August 28, 2009

Subject: Dam Inspection Report for Clarks Lake Dam, Field File No. 58.03, Dam Key Sequence No. 1189, Door County

Photo 1, spillway structure, view from right abutment

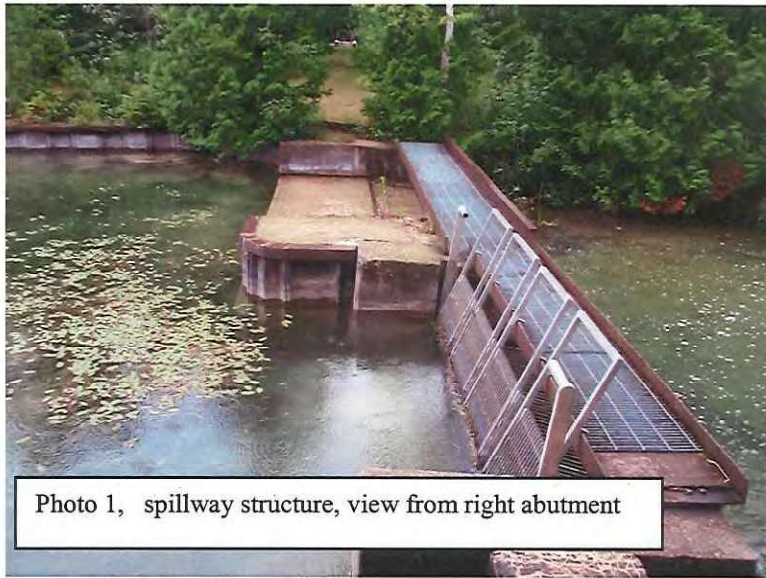
Trees and brush were noted growing on both the right and left embankments near the concrete abutments and steel sheet piling. Photo 1 shows the left side of the dam and the trees that need to be removed. Photo 3 shows a portion of the vegetation that needs to be removed along the right embankment.

Tree removals and removal limits were discussed with Mr. Dan Woelfer (Town of Sevastopol) during the inspection. All the trees and brush within 10 feet of the dam right and left side abutments are to be removed. Tree removal is to include the complete removal of the stumps and the roots, filling of the holes created with firmly compacted tight soils, adding topsoil and grass seed to establish grass growth. I have included our Fact Sheet on "Vegetation Control on Dams" for your information.
